**McLean's Mountain Wind Farm**

**Re: McLean's Mountain Wind Farm Project  
Renewable Energy Approval (REA) - Amendment**

*Modifications Document for  
REA Amendment - March 2013*

## McLean's Mountain Wind Farm Figure A-2: Project Components Site Plan

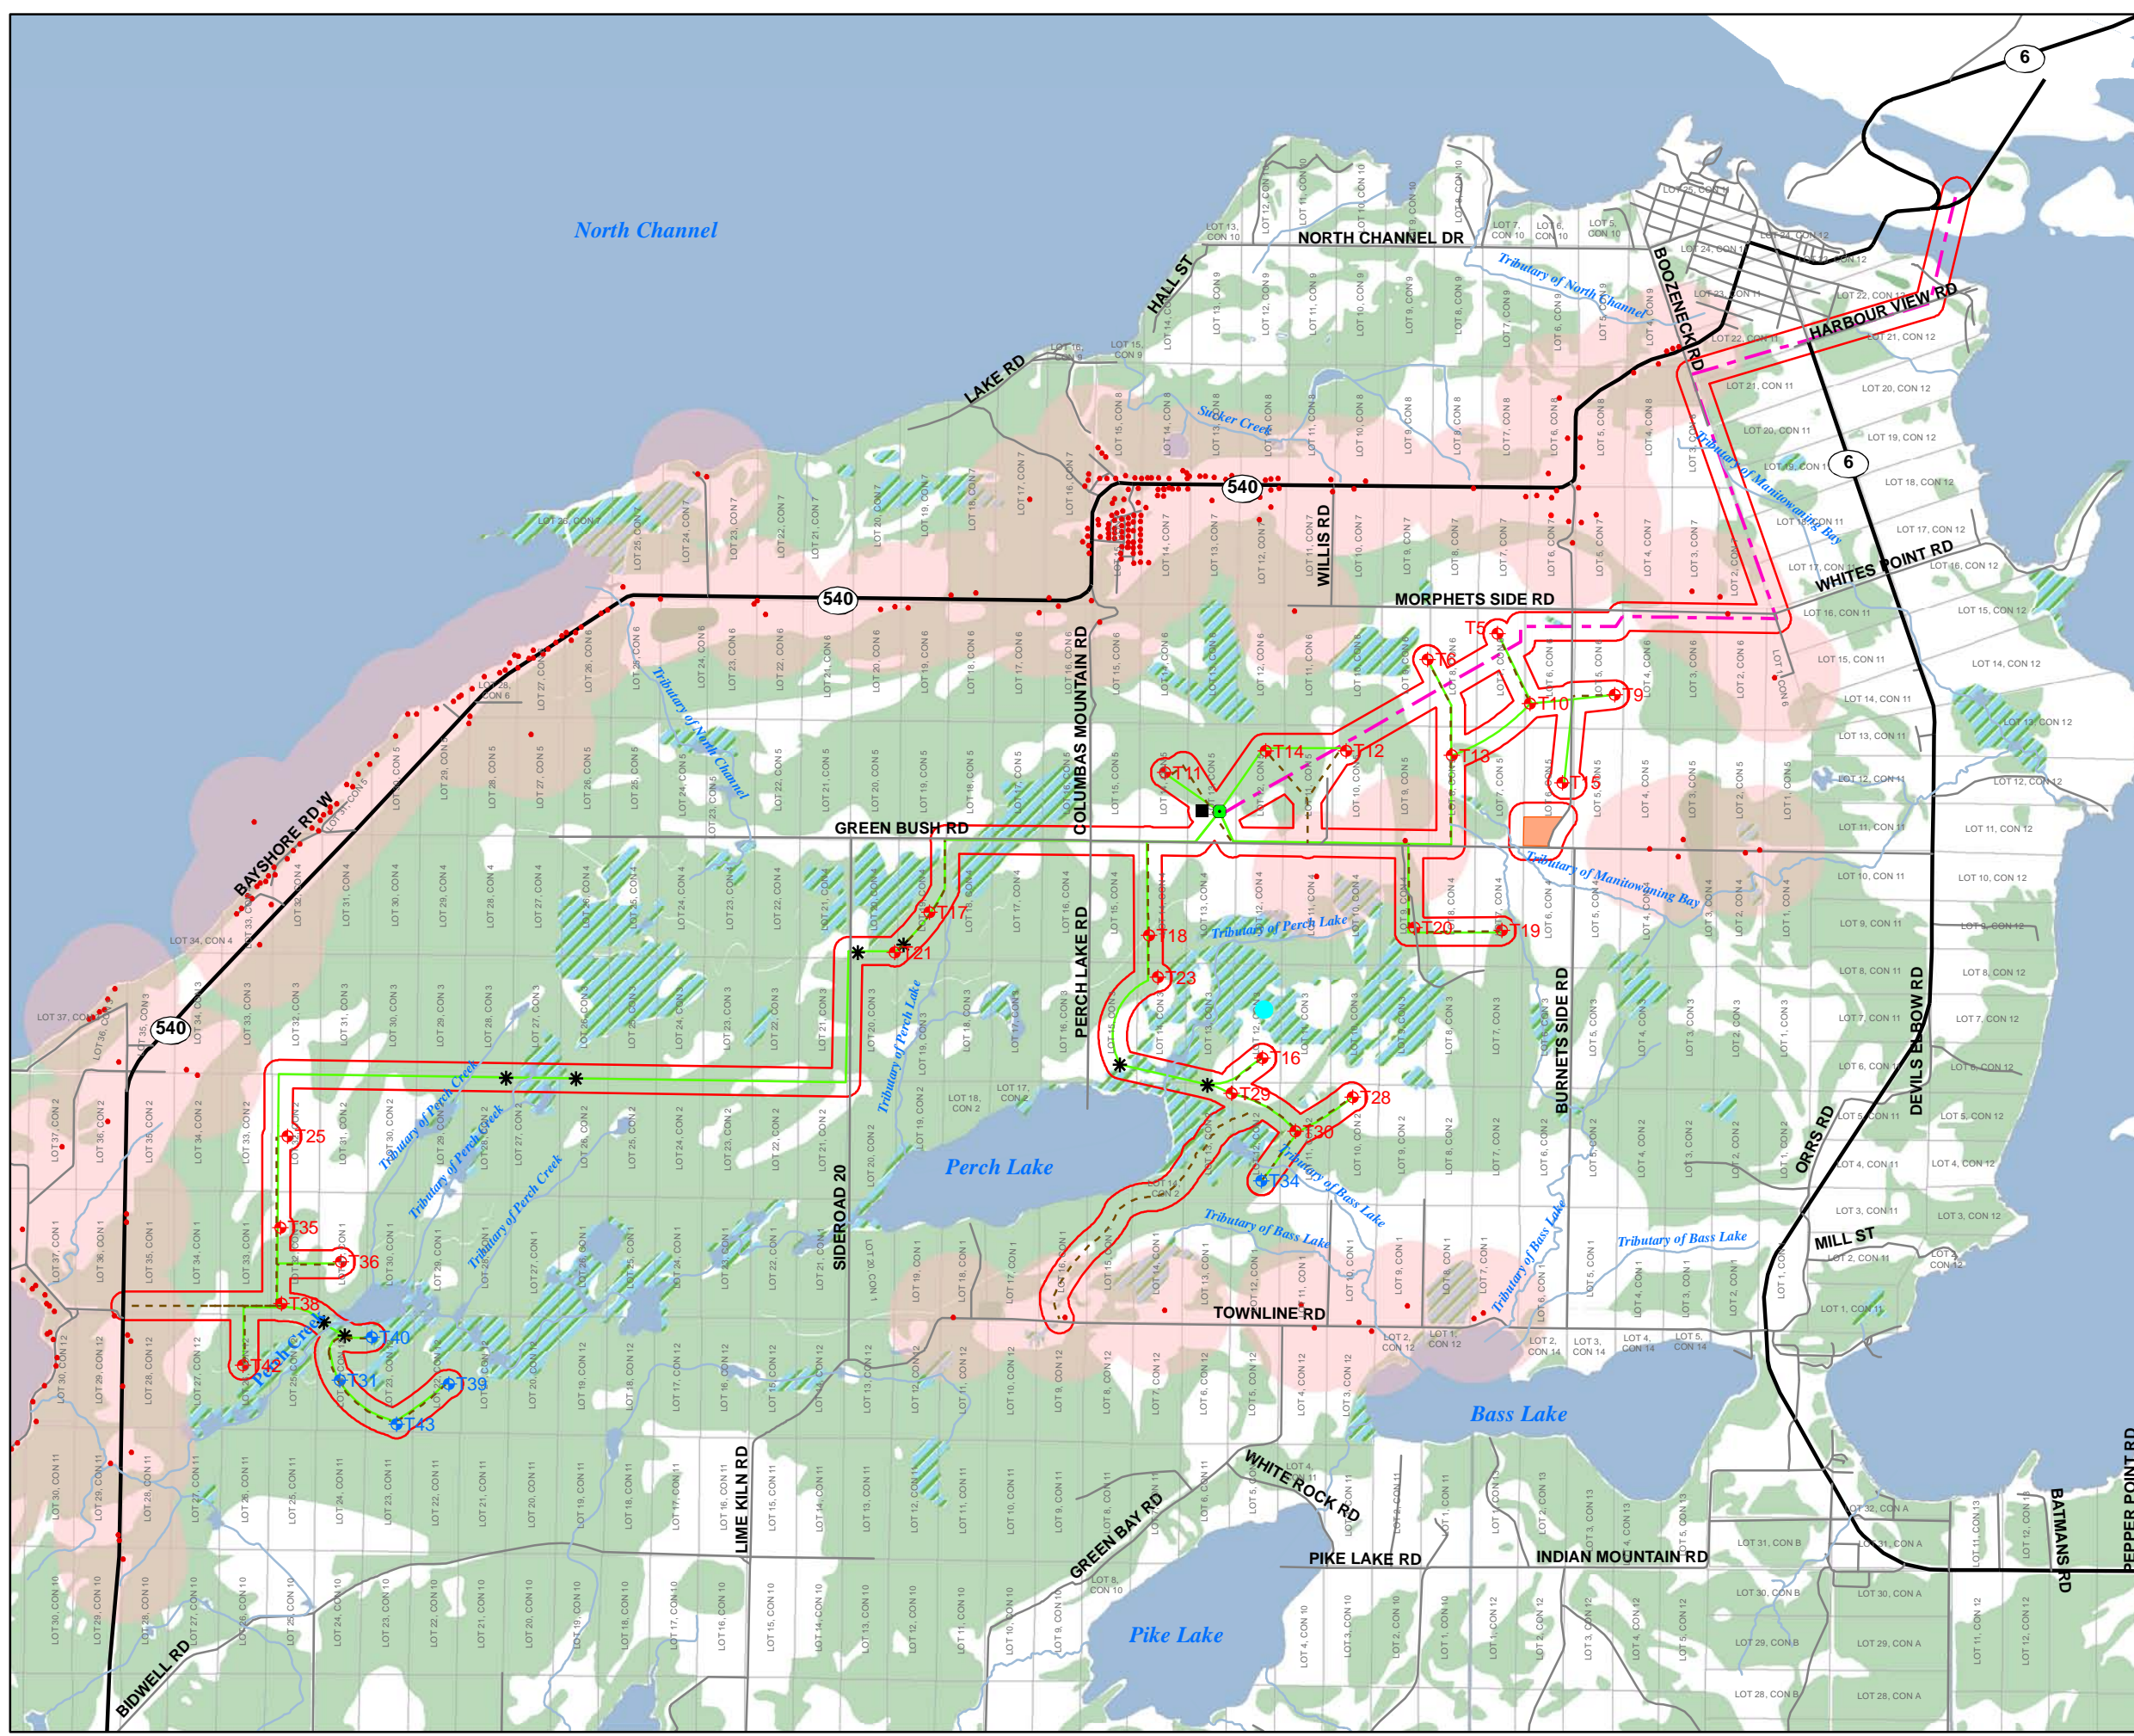
The original site plan submitted with the REA application is provided in *Appendix A*. The revised site plan, based on the changes discussed above, is provided in *Appendix B*. To easily compare the final site plan and changes with the original, *Appendix C* provides a site plan identifying original components that remain the same, those being relocated and those being removed. While only 24 turbines will be erected, a total of 29 turbine locations were submitted for permitting in the REA application and were approved. *Appendix C* identifies the location of the extra permitted sites.
